Rosefield Solar Farm

Chapter 13: Noise and Vibration Figures

APFP Regulation Reg 5(2)(a)
Planning Act 2008
Infrastructure Planning
(Applications: Prescribed Forms
and Procedure) Regulations 2009
EN010158/APP/6.3.2
Revision 2
Deadline 1
March 2026
Rosefield Energyfarm Limited

ES Volume 3: Figures

TITLE:
 FIGURE 13.1 STUDY AREA AND
 RECEPTORS

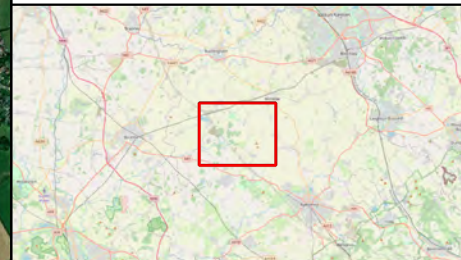
Drawing number	Revision number	Drawing title	Scale	Reason for revision
13.1	02	Study Area and Receptors	1:30,000 @ A3	Receptor labelling amended to be consistent with other figures.
13.2	01	Baseline Survey Locations	1:30,000 @ A3	No change made
13.3	01	Operational Phase Noise Contours (without additional mitigation)	1:25,000 @ A3	No change made
13.4	01	Operational Phase Noise Contours (with additional mitigation)	1:25,000 @ A3	No change made
